ADDENDUM

ADDENDUM No.	2	GMCa JOB #:	202507 MBD
ISSUE DATE:	04.24.26	SBC #:	366/009-07-2025
PROJECT:	MTSU Beasley Hall Renovations – Phase I		323 Friendship Street Murfreesboro, TN 37132
OWNER:	Middle Tennessee State University		1301 East Main Street Murfreesboro, TN 37132
ARCHITECT:	Gilbert McLaughlin Casella architects		2305 Kline Ave, Suite 200 Nashville, TN 37211

1 ENLARGED INTERIOR FINISH PLAN - LEVEL I - LOBBY/LOUNGE
 SC: 3/8" = 1'-0"

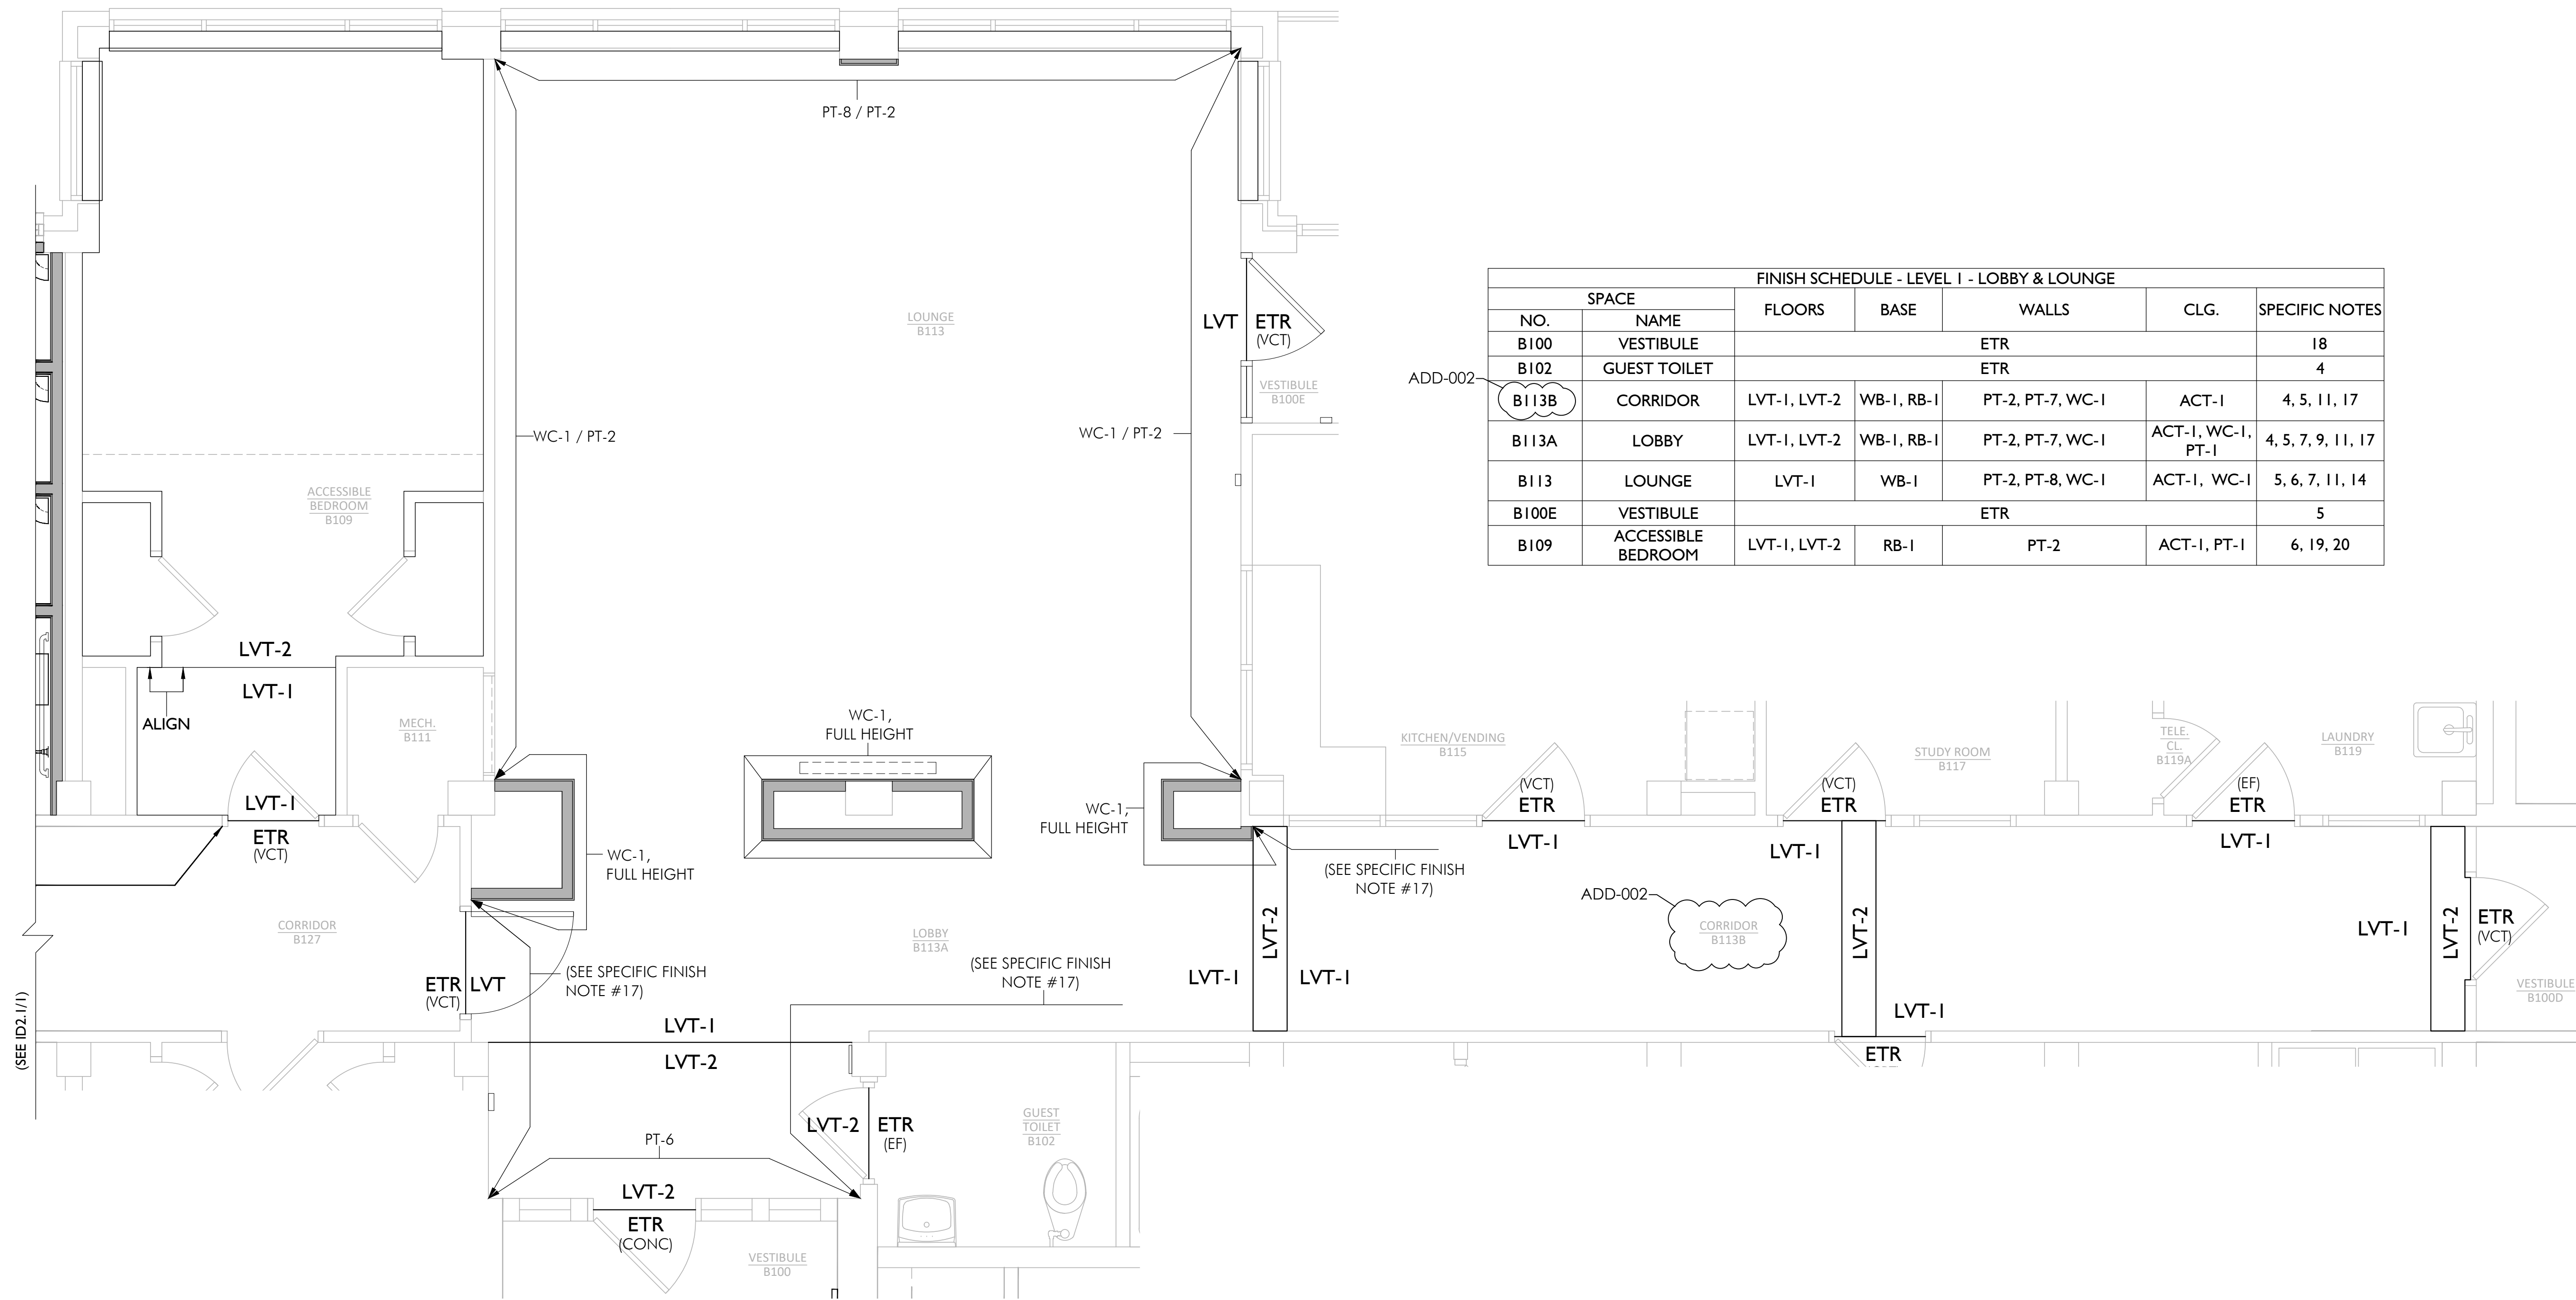
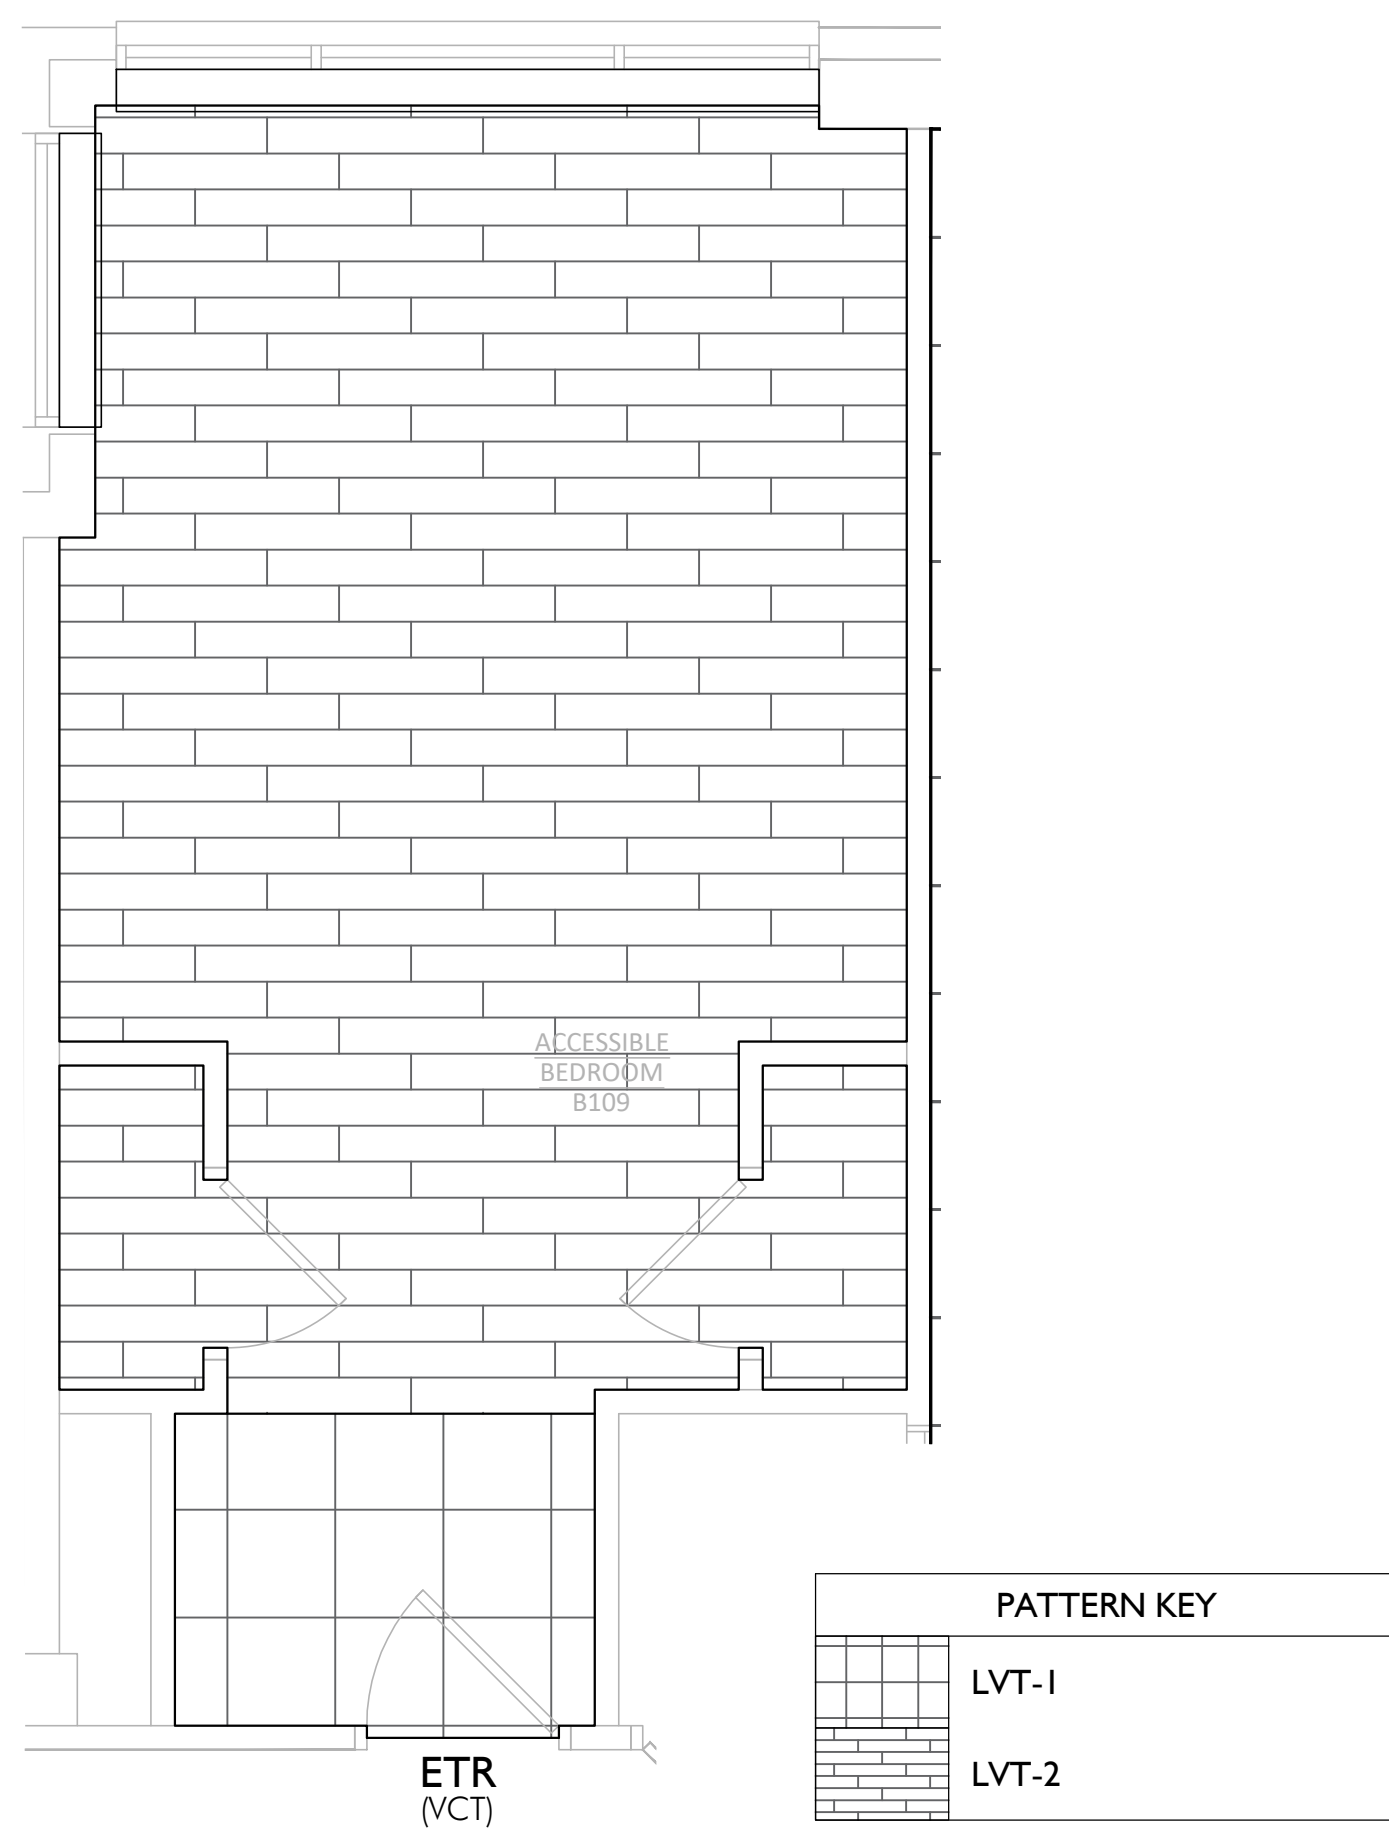
- 8. ID2.0 ENLARGED FINISH PLANS & FLOORING PATTERN PLAN – LEVEL 1
 - a. On Plan #1-Level 1, Corridor-B103 was relabeled Corridor-B113B
 - b. On the Finish Schedule, Corridor-B103 was relabeled Corridor-B113B
